## HISTORIC AND DESIGN REVIEW COMMISSION

**HDRC CASE NO:** 2016-324  
**ADDRESS:** 2411 BROADWAY  
**LEGAL DESCRIPTION:** NCB 6296 BLK LOT 102 (MILL RACE DEVELOPMENT)  
**ZONING:** C2 RIO-1  
**CITY COUNCIL DIST.:** 1  
**APPLICANT:** Roland Perez  
**OWNER:** Andrew Toscano  
**TYPE OF WORK:** Exterior modifications, additions and signage  
**REQUEST:**

The applicant is requesting a Certificate of Appropriateness for approval to:

4 Right Elevation  
SCALE: 1/4"=1'-0"

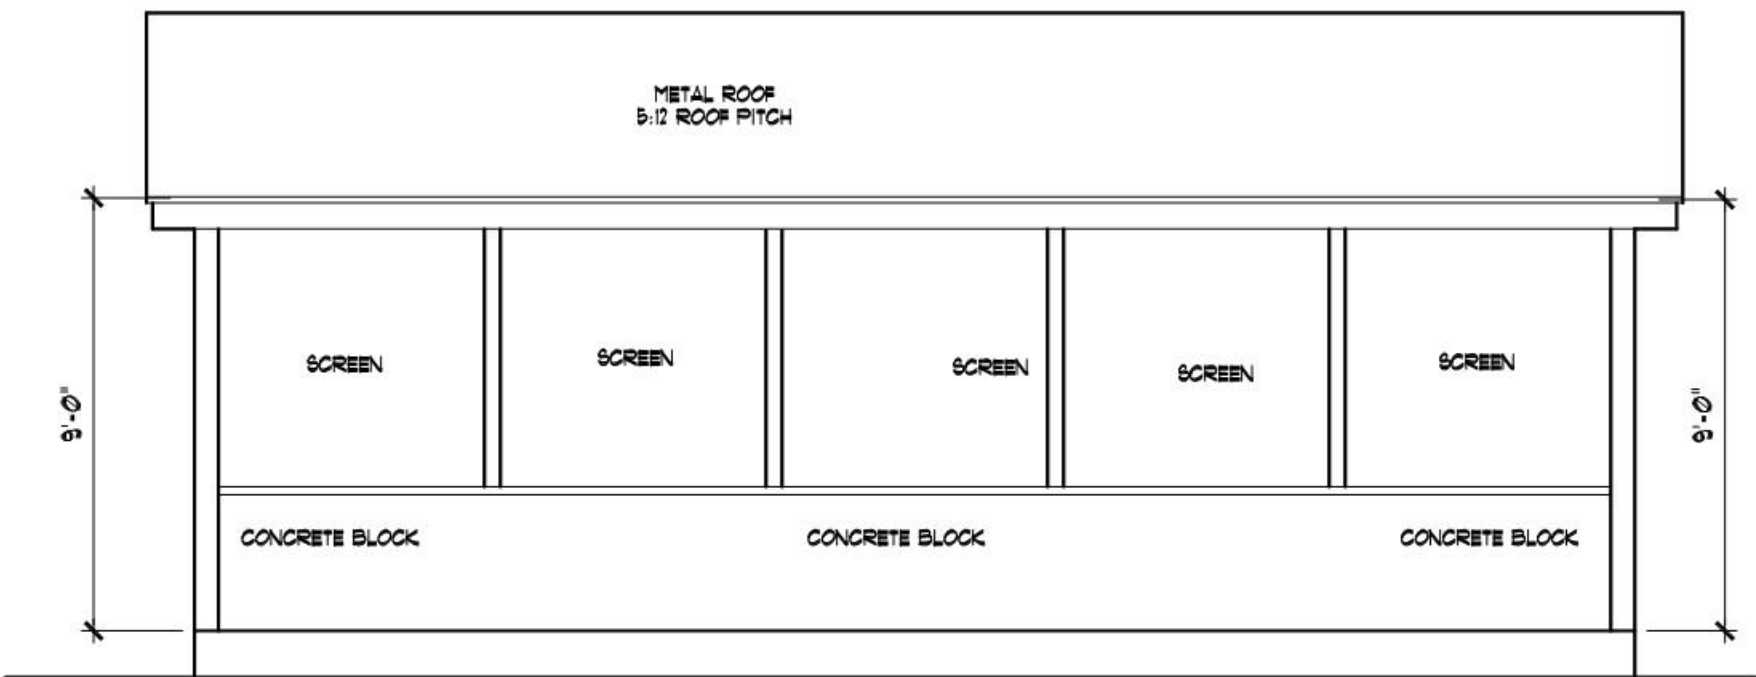
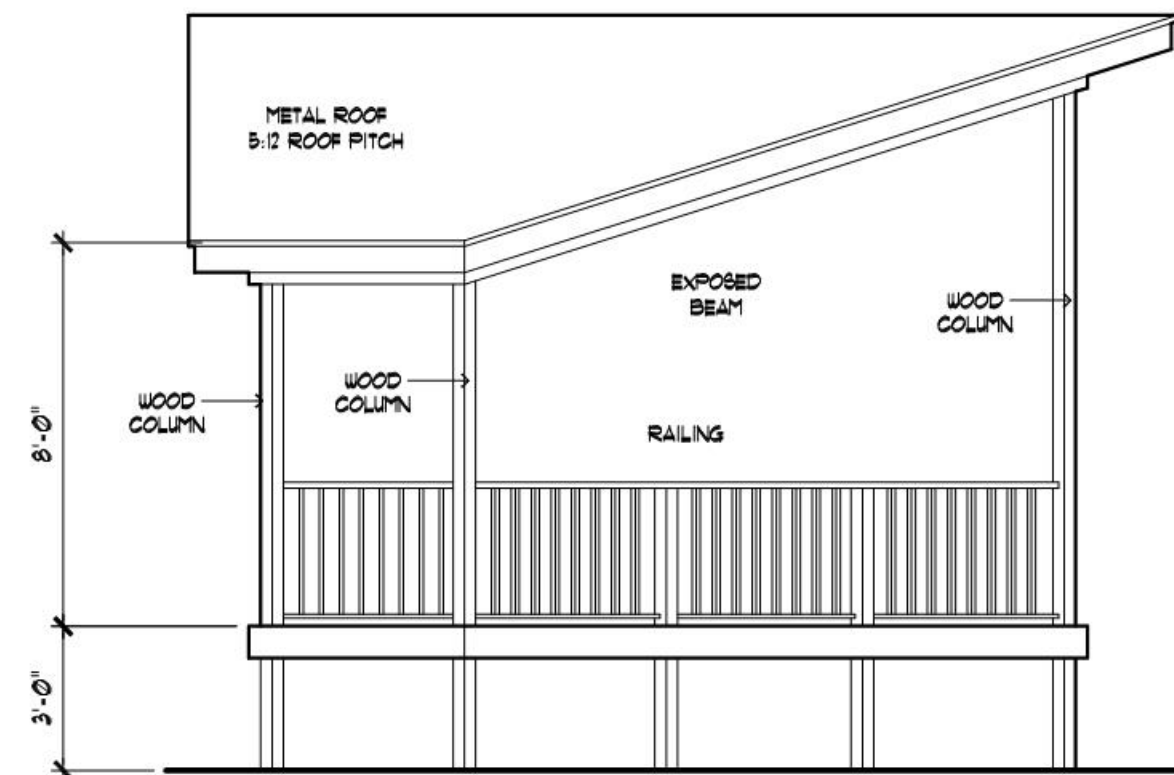
- c. **REAR DECK** – At the rear of the brick structure, the applicant has proposed to remove the existing rear landing and stair and construct a new deck with stairs. The deck will be constructed of treated red wood and feature a railing of 36 inches in height. Staff finds that the applicant’s proposed modifications are appropriate and consistent with the UDC Section 35-674(d).
